**ADDENDUM
PLAN COMMISSION STAFF REPORT
PC 25-015**

Agenda Item: PC 25-015: SUBDIVISION, proposed 4-lot re-plat of Centennial Village, Lot C

Subject: Addendum to January 13, 2026 Plan Commission Staff Report

Calumet Avenue & 45 th Avenue	Date: 2026.01.21
--	--	------------------

Geometric Obstacles

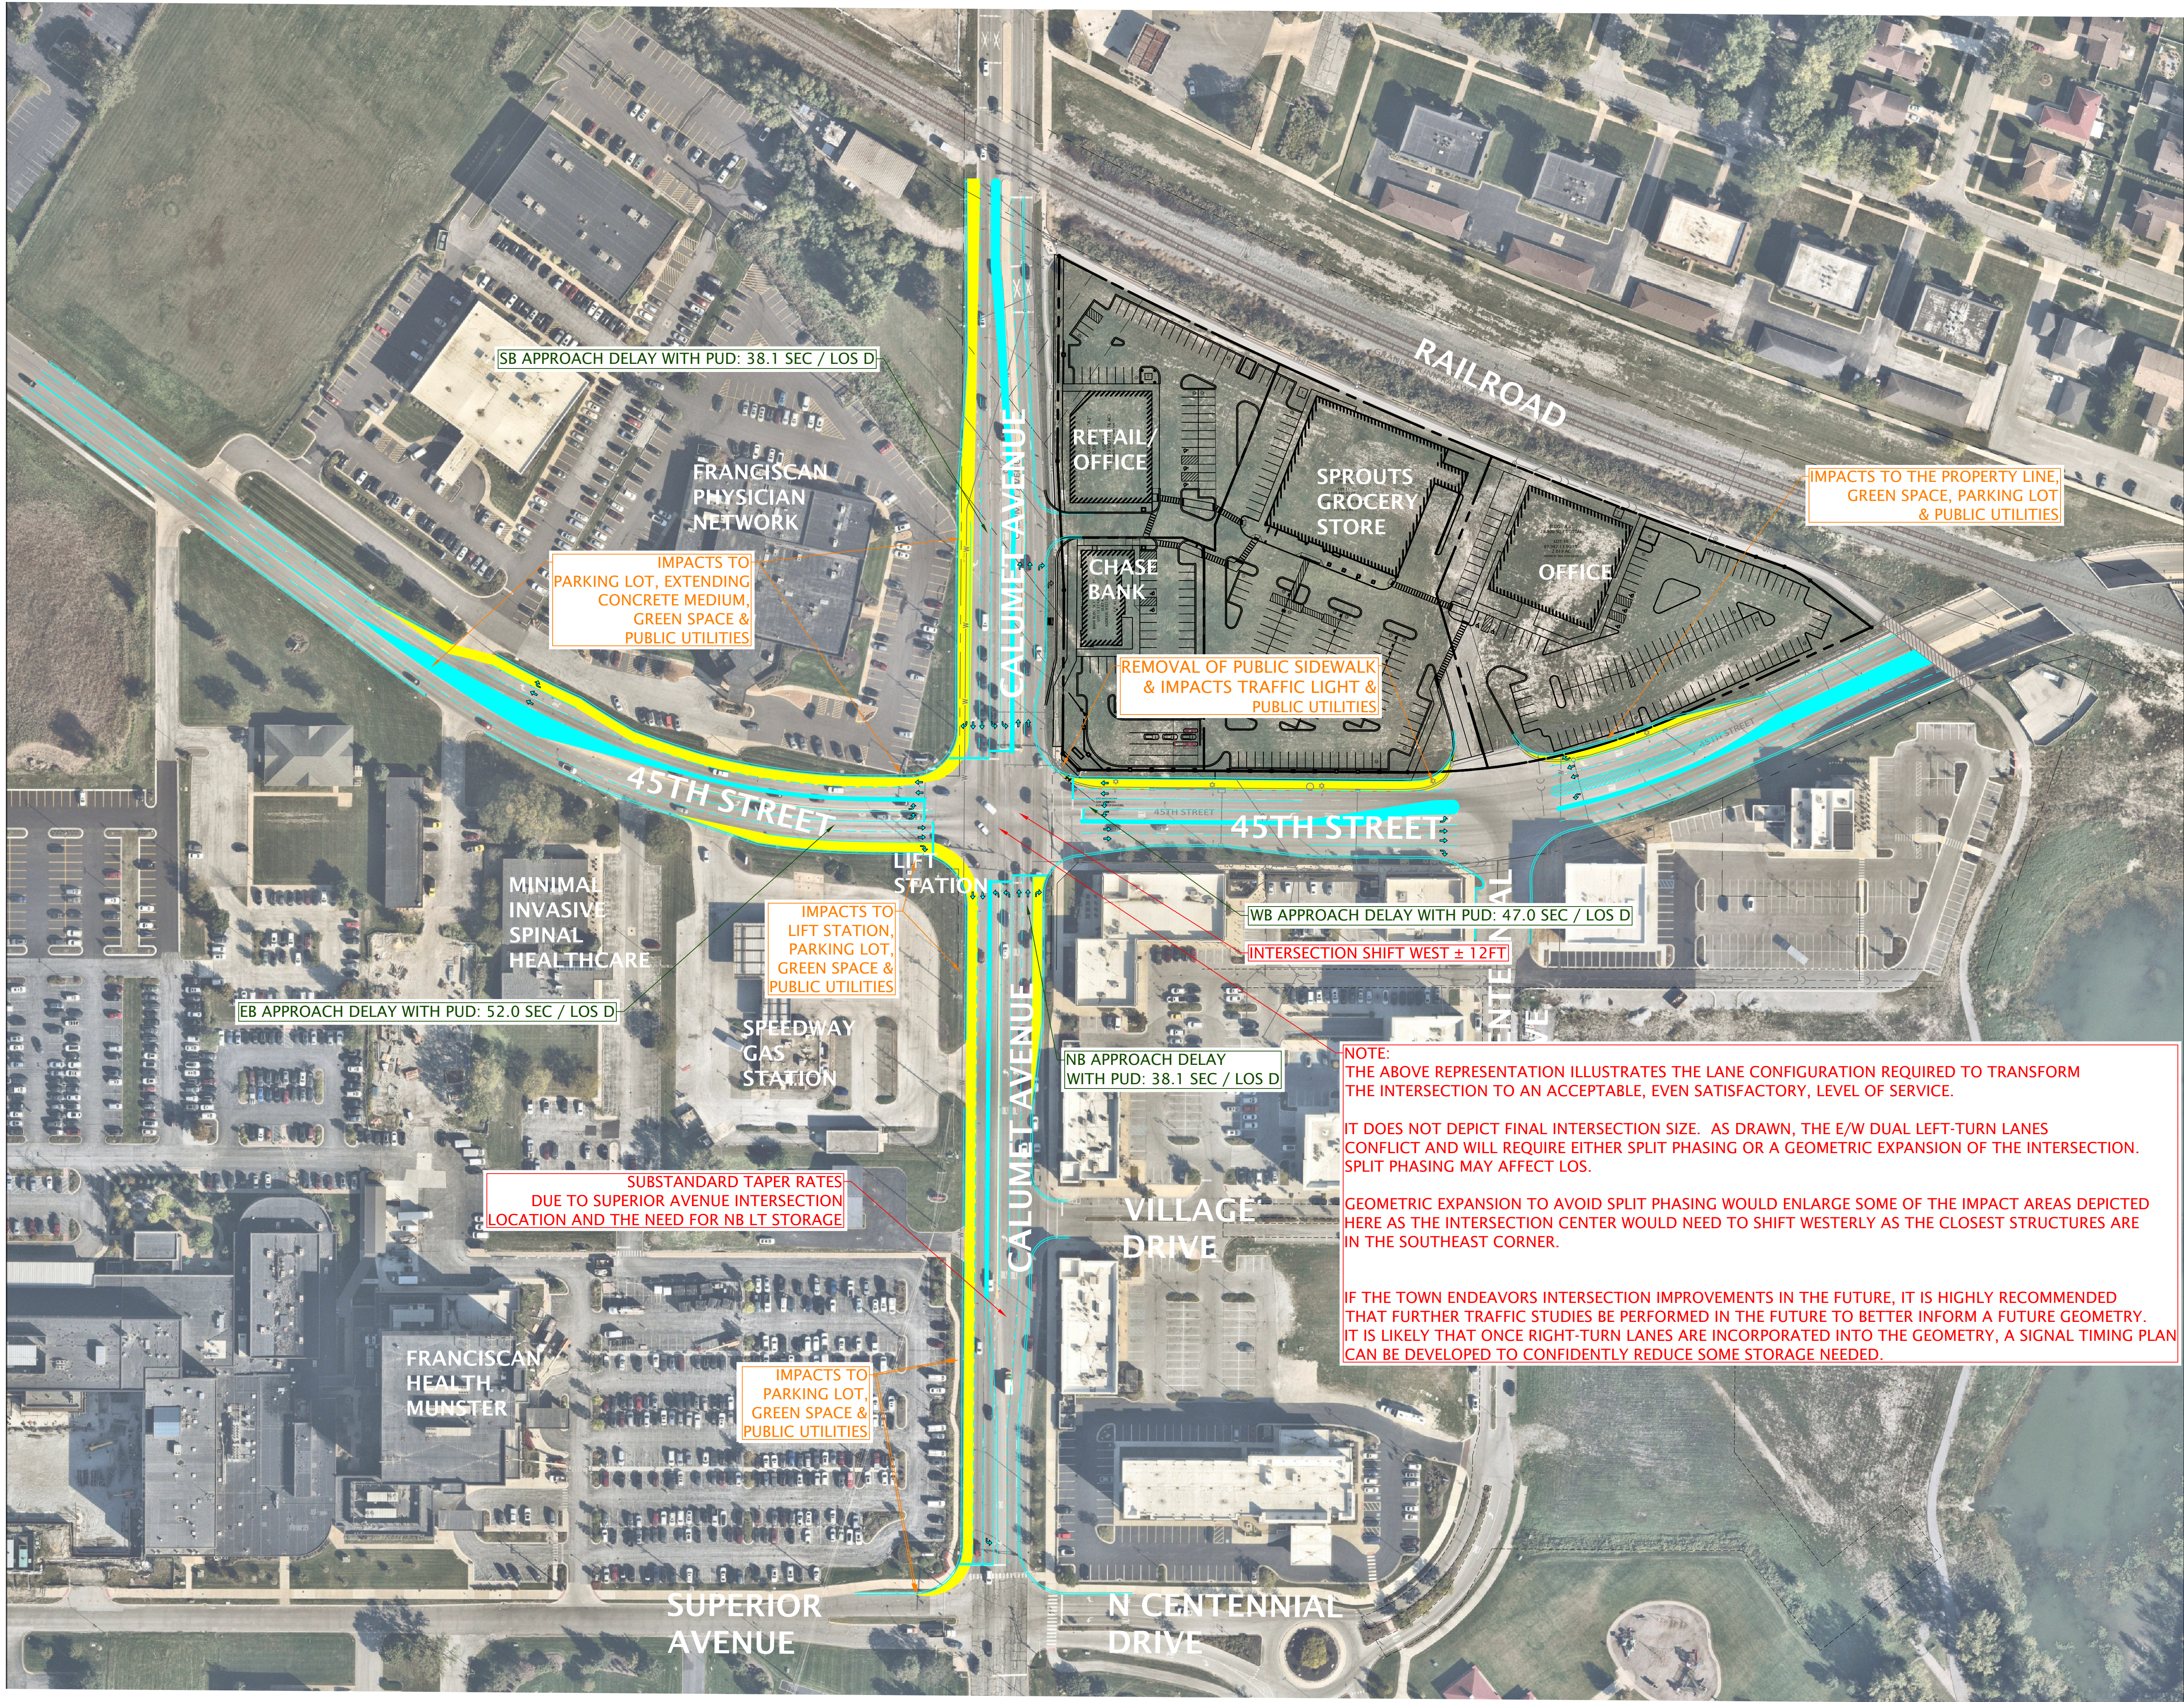
As illustrated in the attached exhibits, consideration of widening both roadways in the future will require tackling issues likely avoided during the reconstruction of the intersection over the past 10 years.

Installation of an eastbound right-turn lane will almost certainly require relocation of a sanitary lift station in the southwest quadrant of the intersection.

Installation of the dual left-turns lanes and their associated widening will almost certainly require ROW takes and possible parking lot impacts to the development in the northwest quadrant of the intersection.

Installation of a northbound right-turn lane will likely require realignment of Calumet Avenue through the intersection due to existing buildings in the southeast quadrant that are close to existing ROW lines.

Holistically, the intersection will need to get larger as the current east/west stop bars are not a sufficient distance from each other to prevent the left-turn movements from conflicting with each other. While this obstacle may be solved through different signal phasing, that answer is best determined at a later date.
